From: Jones, William V., EMNRD
Sent: Thursday, October 22, 2009 10:53 AM
To: 'vltruax@basspet.com'
Cc: Ezeanyim, Richard, EMNRD; Warnell, Terry G, EMNRD; 'Wesley_Ingram@blm.gov'
Subject: Disposal Application for BOPCO: James Ranch #48 30-015-27791

Re: Application to Inject Fluid – James Ranch Unit #48

A review of BOPCO L.P.'s application to inject fluid into the James Ranch Unit #48 has been completed.

James Ranch Unit
BOPCO, L.P.

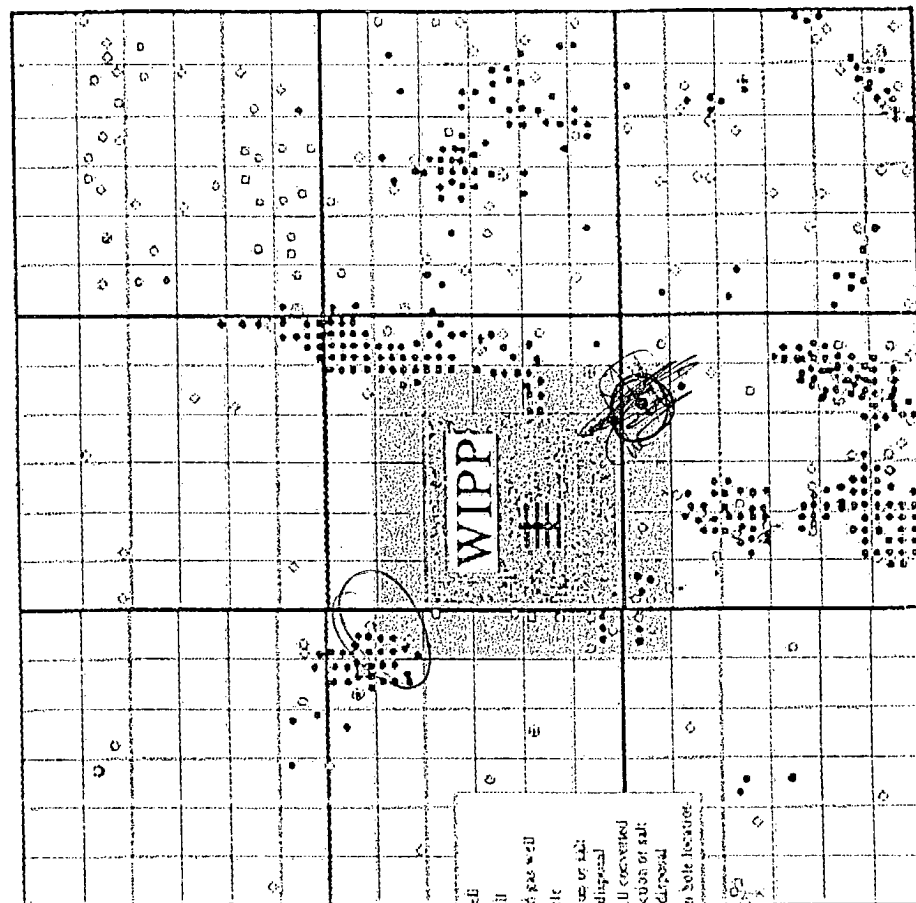
1. The wellbore penetrates potash ore zones. Any leak could catastrophically dissolve halite and potash resources creating back and floor instability within the mine workings, which would be a hazard for miners.
2. The injection has the potential of affecting future mining zones of measured ore depending on the fluid migration.
3. James E Federal #15 (30-015-27078) does not have cement in place behind casing from 3700-6013'. This well is within one half mile of the proposed injection well.
